Subject: Duke Energy Florida, LLC
Hines Energy Complex
Conditions of Certification PA 92-33
Petition for Modification-Brine Handling System
Response to Determination of Completeness Letter dated May 6, 2025

PROJECT: DUKE ENERGY HINES ENERGY COMPLEX SOUTH LAYDOWN AREA
 TITLE: FLOW FROM ADDITIONAL PERMENANT IMPERVIOUS AREA
 DATE: 2025-02-20

R/O Brine Evaporation Pond Project
Duke Energy FL - Hines Energy Complex, Polk County, FL

Plant Area Drainage Pond

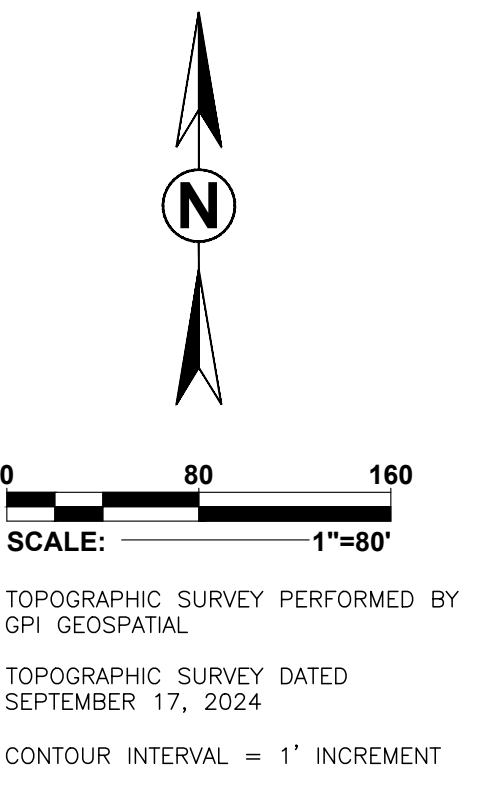
Ardaman believes that the Downstream Hazard Potential will classify as Low Hazard Potential (LHP) in that failure is not expected to result in the loss of human life and may result in low economic, environmental, and/or environmental losses, that will be largely limited to the owner's property. An Emergency Action Plan and Condition Assessment Report are not required for dams classified as LHP. An image of the project location relative to downstream landforms is attached as Figure 1. An aerial image showing the project location adjacent to the plant island ditch system and containment area is shown as Figure 2. The plant island ditch system surrounds the proposed Spray Ponds and discharges all runoff from the Hines Energy Center Complex plant area to the

containment area. Any discharge from a dam breach or mis-operation should be captured in the plant island ditch system and discharged to the containment area.
